April 4, 2018

Thank you for having Ms. Barbas of the New NY Bridge Project write us on March 5 regarding the Shared Use Path (SUP). We appreciate the work to improve the path's safety and accessibility. It is welcome news that the latest plans remove swing gates, switch dismount signs to yield signs, improve warning signs for people driving.

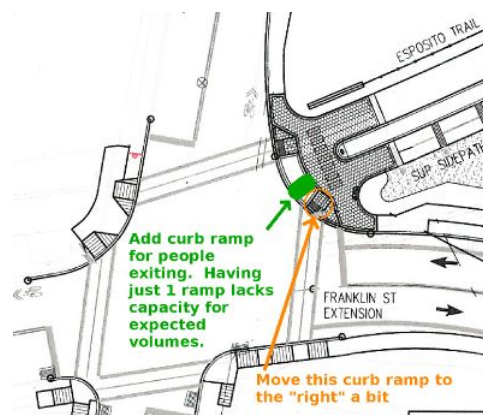
Cycling is quite safe due to low mass and low speeds. Chicanes will force people to change velocity and course -- generating rear end, wheel overlap, side swipe, fall over and head on crashes. So chicanes would wind up creating danger where it didn't exist before.

These conflicts will be significant given **the chicanes would narrow a path that will already be below FHWA's width guidelines**. The Side Path without chicanes will be only 10' wide. The path will easily see more than 150 users / hour / direction, for which FHWA recommends paths be 12 - 14' wide. (p 4-5, "[Small Town and Rural Multimodal Networks](#)," FHWA, 2016)
